UNITED STATES  
NUCLEAR REGULATORY COMMISSION  
WASHINGTON, D. C. 20555

MEMORANDUM TO: R. Mattson  
V. Stello

SUBJECT: TMI-2 PLANT MODIFICATIONS FOR COLD SHUTDOWN  
(SEE APPENDIX)

TMI-2 PLANT MODIFICATIONS  
FOR ACHIEVING COLD SHUTDOWN\*

## FIGURE 2

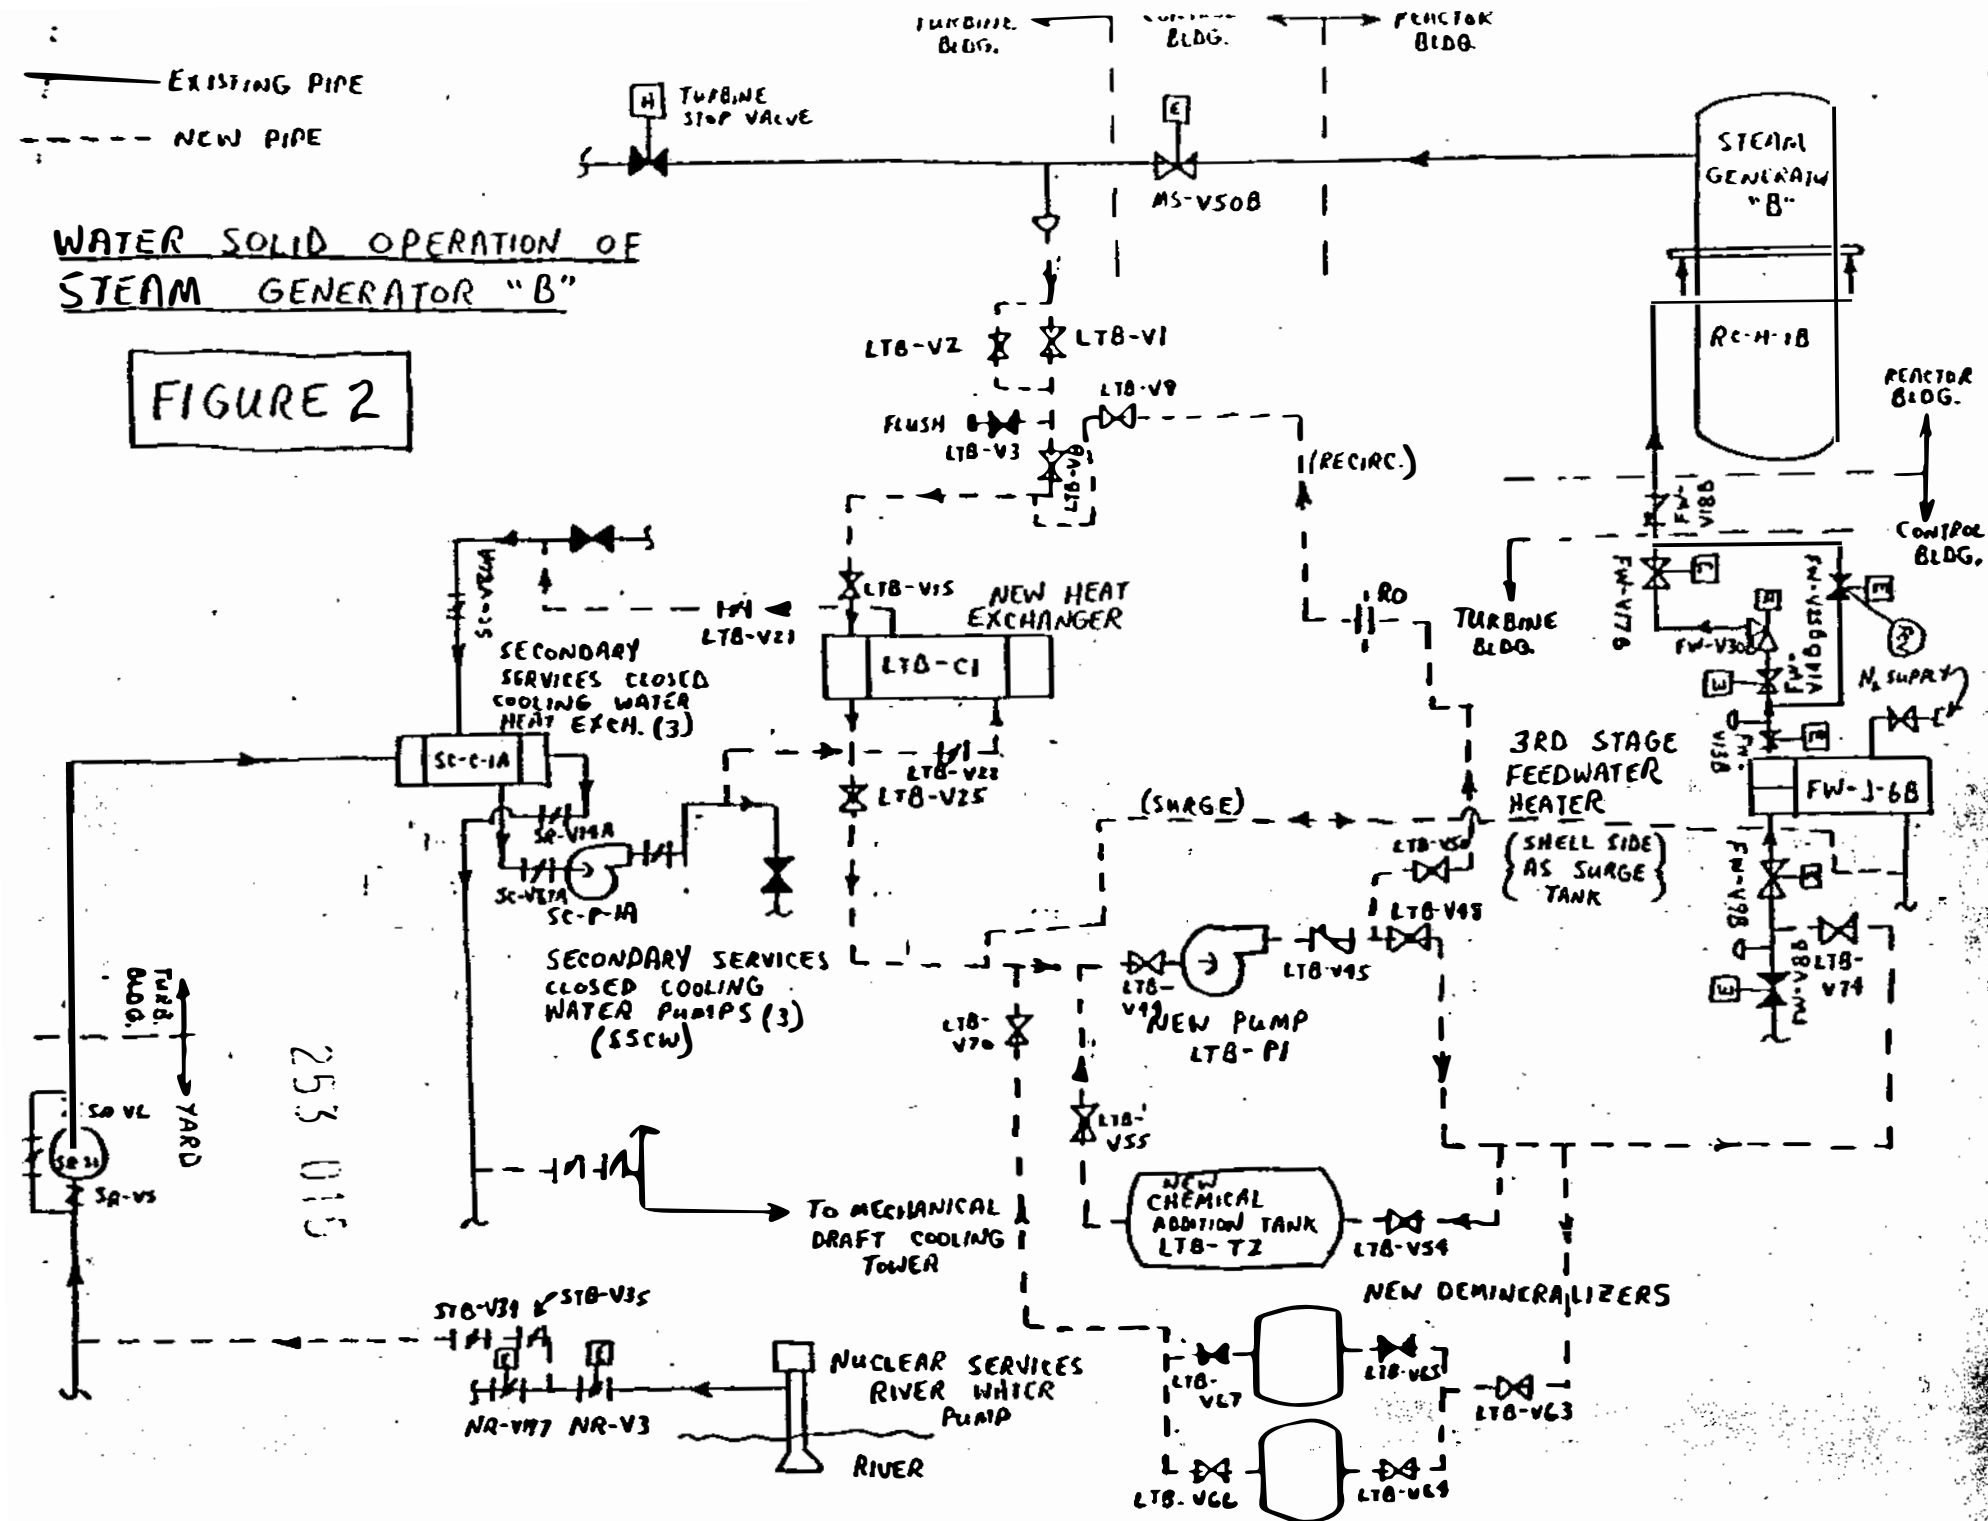
A specific concern that we have addressed in our review is the structural adequacy of that portion of the Main Steam piping system which as incorporated into the OTSG cooling system will contain solid water in lieu of the pressurized steam for which it was designed. Components in the system will not experience any significant dynamic loads. Special precautions will be taken during initial filling and startup of the system to minimize the potential for water hammer. Loads that will be experienced include pressure, deadweight of water, and thermal expansion. Since the system will be operated at a maximum pressure of about half the design pressure of the piping and its maximum operating temperatures will be considerably lower than the design temperature of the main steam piping; stresses resulting from these loads will be minimal.

After assembly and prior to initial operation of the plant, the existing piping was hydrostatic tested and at that time was water filled. Thus the piping and its supports have been demonstrated to be adequate for the weight of the water.

In order to minimize piping deflection, the licensee has specified that selected spring hangers be pinned. We concur with this requirement.

Figure 1  
Location of Equipm.  
in Turbine Bldg

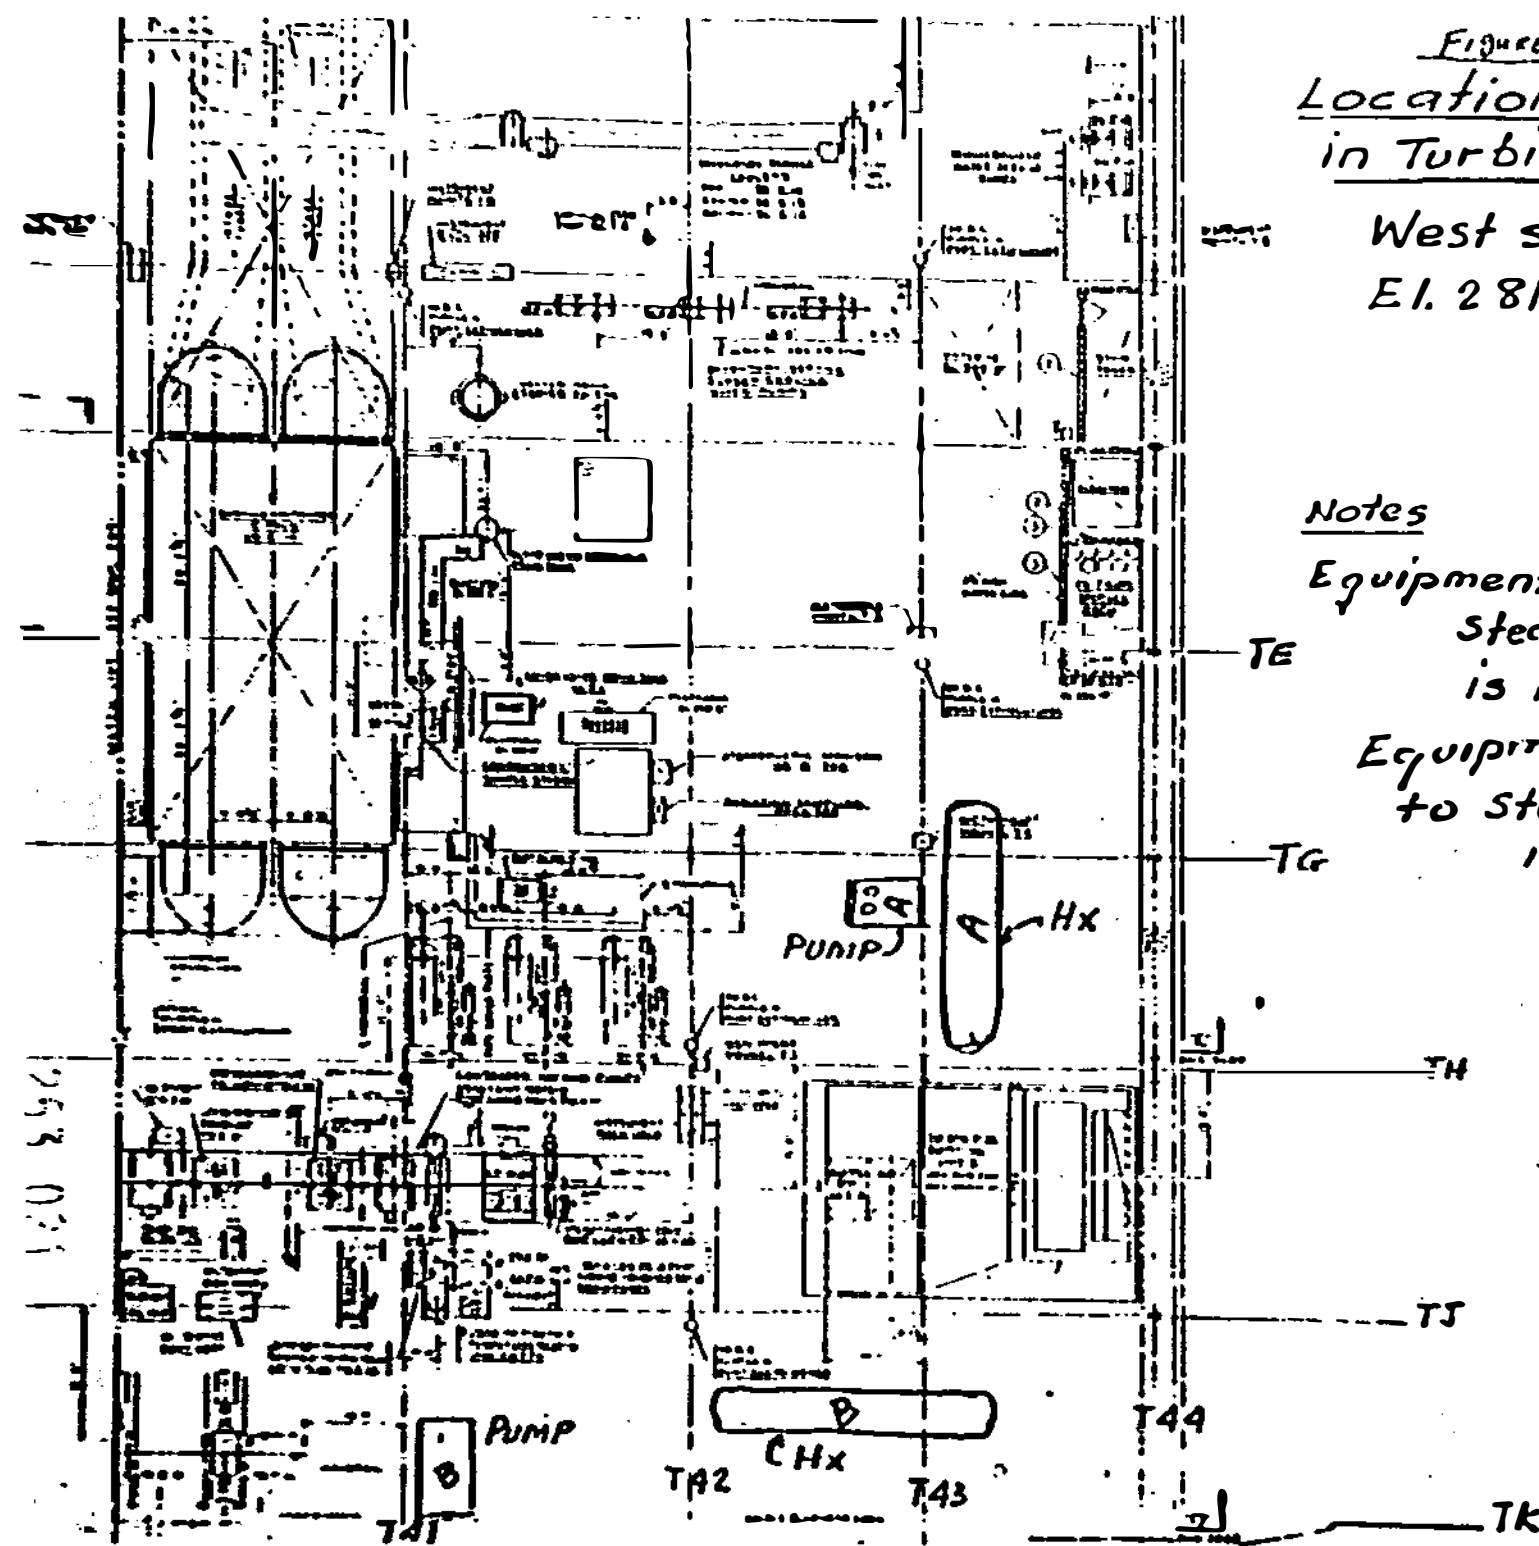
Modification of Steam Generator "A" and Steam Generator "B" involves installation of one pump and one heat exchanger for each steam generator. The new equipment will be installed in the north-west end of turbine building at elevation 281'-8", between column lines TJ and TK in north-south direction and T41 and T44 in east-west direction. The enclosed Figure 1 shows the general area of location of the above equipment.

The heat exchanger for steam generator "B" weighs 35 kips wet and is supported on two saddles, 2'-0" by 4'-0" each. The pump for this steam generator weighs 13.7 kips.

The heat exchanger for steam generator "A" weighs 135.3 kips wet. It is approximately 33 ft. long and is supported on two saddles 2 in. wide and 4'-3" long located 13'-0" apart.

Examination of the existing structural drawings of the turbine building area, where this equipment is to be installed, reveals that the base slab is four feet thick, with #11 rebars at 12 in. spacing, each way, top and bottom. Top of the structural concrete base mat is at the elev. 277'-0". The base mat is covered with a 3'-0" layer of lean concrete fill plus approximately 2 in. wearing surface, bringing the top elev. to 281'-8". Assuming 45 degree distribution of the load, and on the basis of the allowable concrete bearing pressure, the

licensee estimated that the maximum load that can be placed over one square foot of the area is 90 kips. Since the heaviest piece of equipment to be installed in this area is the heat exchanger, 135.9 kips, which when distributed over the area of the supporting saddles ( $2 \times 4.67' \times .67' = 6.1$  sq. ft) delivers the load to the floor of 22 kips, the licensee concluded that the slab is capable to support the load. The analysis was performed for the dead and live loads only, under static conditions.

We have concluded that the licensee has performed his analysis in accordance with the methods and procedures which are specified by the appropriate codes and standards. The use of these methods provide a reasonable assurance that the structural elements affected by this modification will perform their intended function.

Fig 2 (Sheet 1)

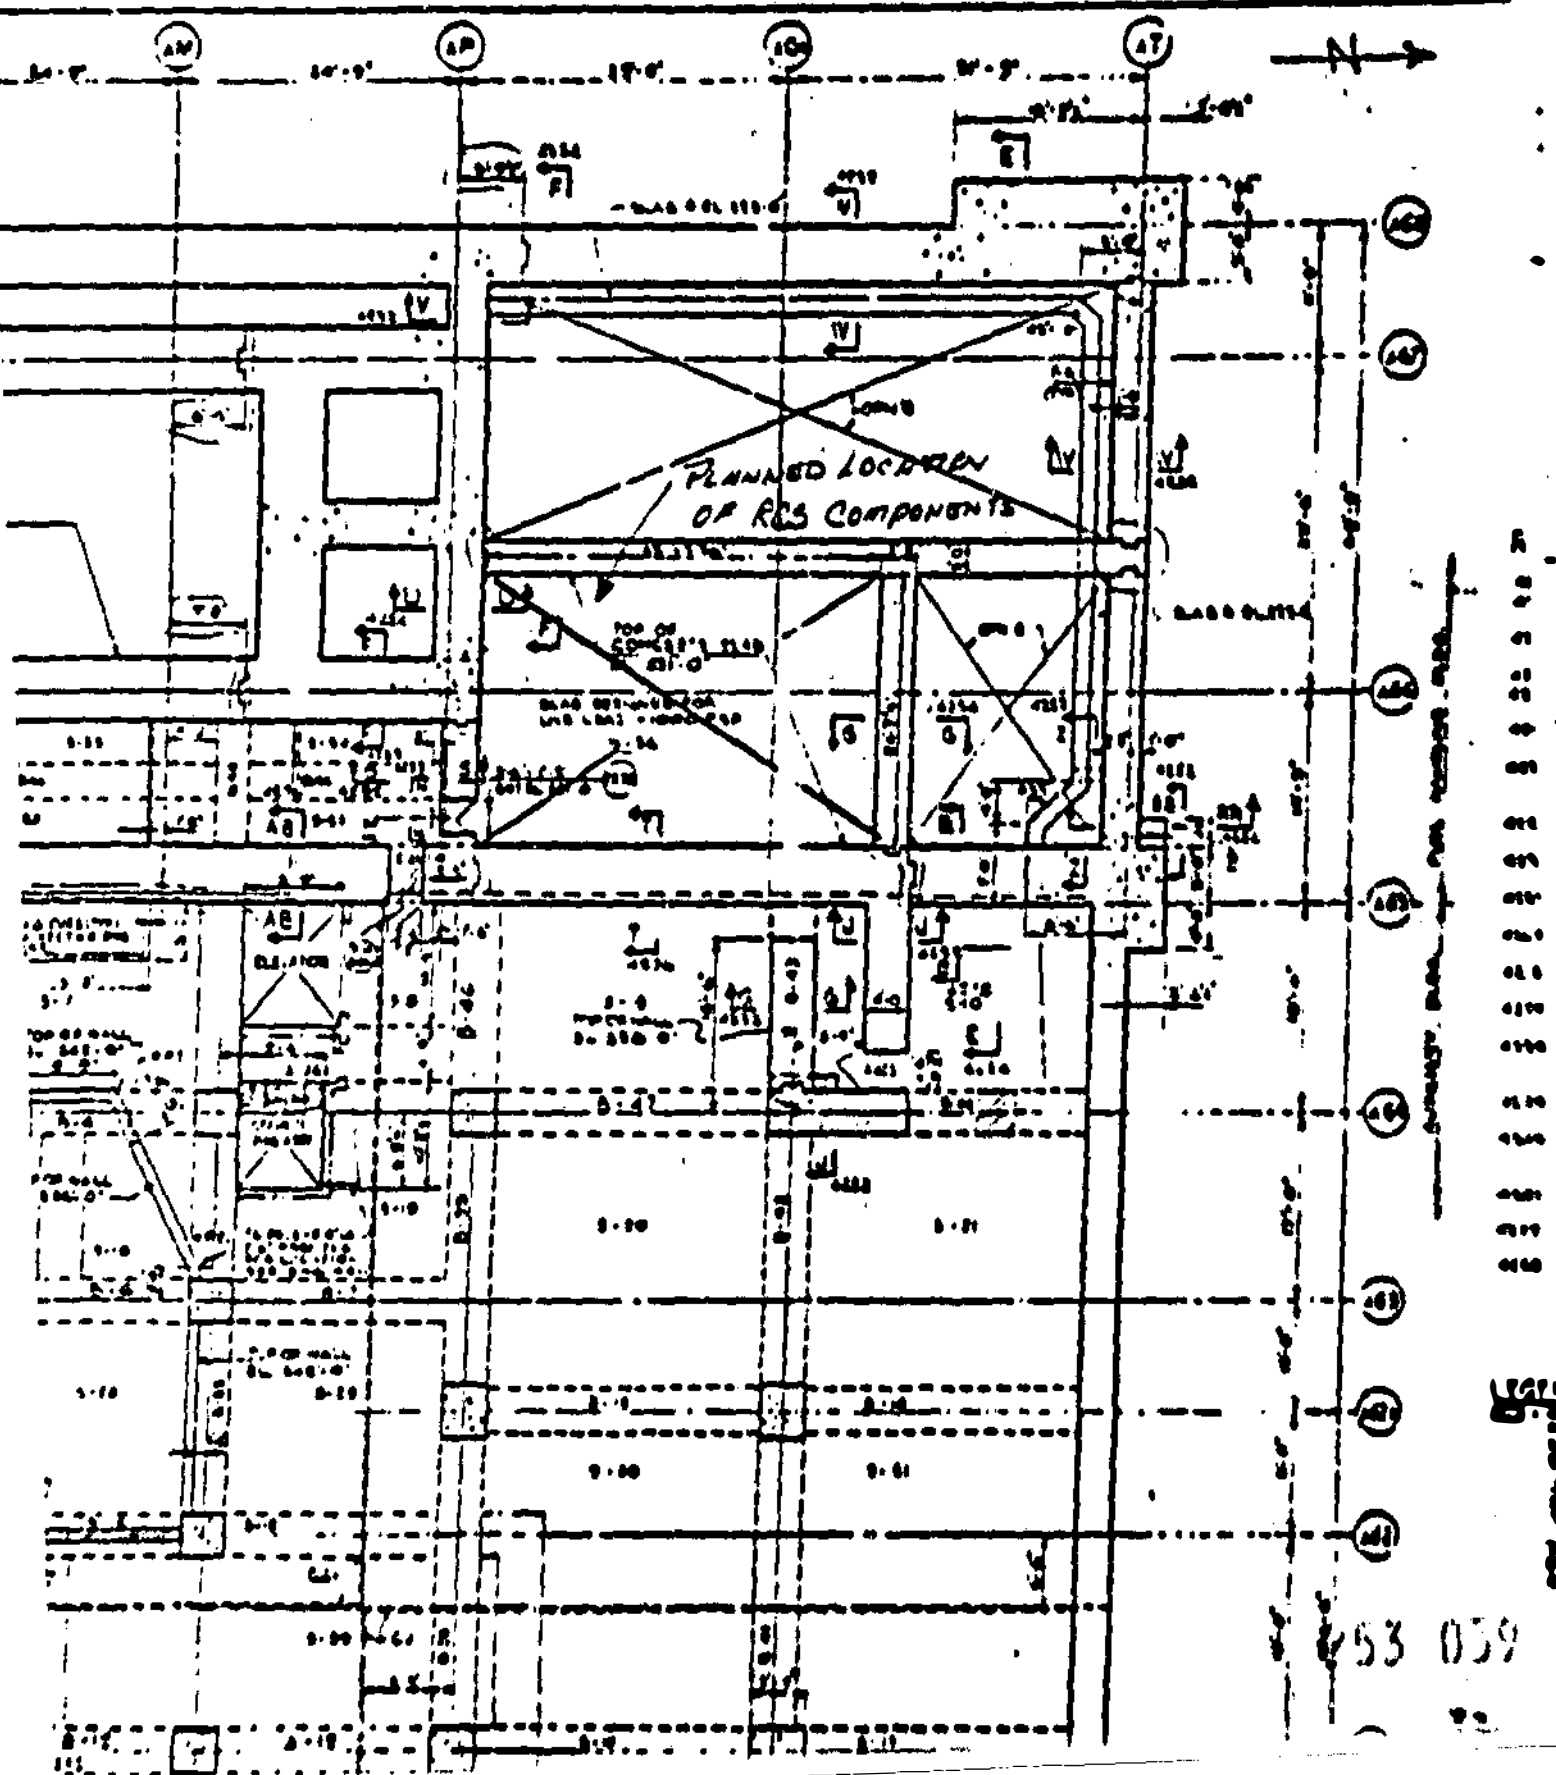
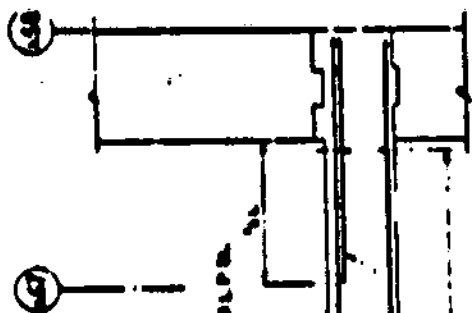
The enclosed Figure 2 (2 sheets) show the conditions of the original structure. The area is located between columns AP and AT in south-north direction and columns A65 and A67 in east-west direction. The slab is three feet thick and the reinforcing steel is #3 at 9 in. top and bottom in north-south direction and #8 at 6 in. top and bottom in the east-west direction. The compressive strength of the concrete is 3000 psi and the yield stress of the reinforcing steel is 60 ksi. The licensee has analyzed the slab for the additional loads resulting from the new equipment and concluded that the stresses will be within the allowables using generally accepted codes. The analysis was performed for the static conditions only. We conclude that the licensee has performed his analysis in accordance with the methods and procedures which are specified by the appropriate codes and standards. The use of these methods provide reasonable assurance that the structures affected by this modification will continue to perform their intended function.
